APPENDIX 12: CHAPTER 12 APPENDICES

12A: Ecology Review Comments dated May 10, 2013

Re: City of Yelm Draft General Sewer Plan – Ecology Review Comments

Yelm General Sewer Plan
Responses to Ecology Comment Letter dated May 10, 2013

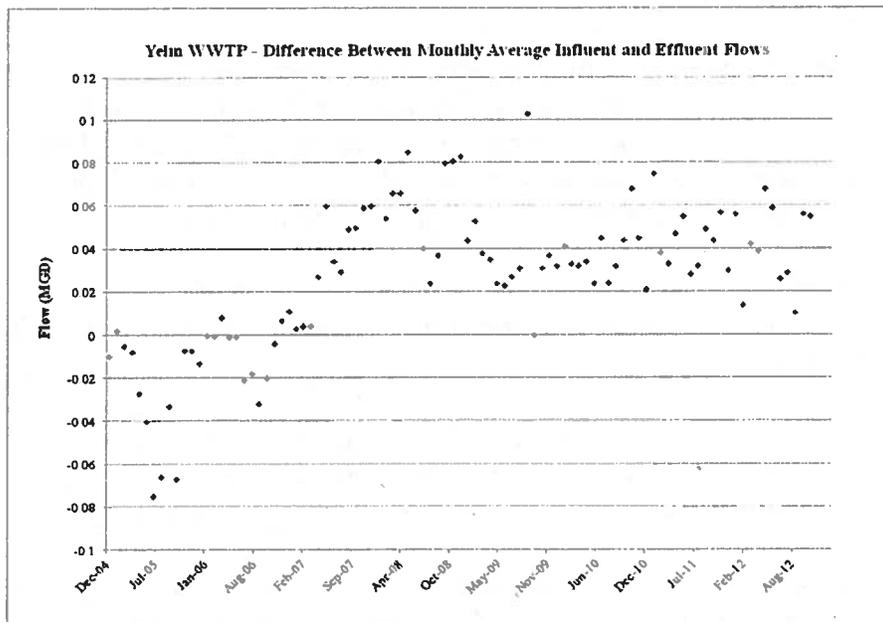
Section 2.6. Page 2-10. We reviewed monthly flow data (influent flow, reclaimed water use, discharge to Power Canal, and discharge to Nisqually River) the city reported on monthly discharge monitoring reports. The data indicate a difference of 30,000 to 60,000 gallons per day between the influent flow and combined discharges. Prior to approximately March 2007, the city reported more effluent than influent flow. From that date to the present, the reported influent flow exceeds the total effluent flows.

Flow meters are not totally accurate but this difference is significant and greater than the inaccuracy of calibrated flow meters. When did the city most recently calibrate the flow meters, and how often does it do so?

<p>City of Yelm Response</p>	<p><i>Table ES-5. Page ES-10. Comment noted. The City will take the initial steps to implement the CIP, including the necessary planning and study efforts, once the GSP is approved.</i></p> <p><i>Section 2.6. Page 2-10. City records indicate that the flow meters have not been calibrated since installation. Table 5-3 and associated table note identify that the City is aware of the problem and will begin implementing annual calibrations. The City is also investigating how much in-plant reclaimed water uses may be contributing to the discrepancy.</i></p>
<p>Ecology Comment No. 5</p>	<p>Section 3.5.2.3.2. Page 3-14. The grinder pump evaluation assumes repairing the pump every 10 years and replacing the pump every 20 years. How did you determine this repair and replacement schedule?</p>
<p>City of Yelm Response</p>	<p><i>Both STEP and grinder pump repair and replacement schedules were based primarily upon manufacturer guidelines (Orenco and E-One, respectively). These guidelines were compared to City of Yelm maintenance staff experience as well as communications with Holmes Harbor Sewer District, which uses both STEP and grinder pumps in its collection system.</i></p>
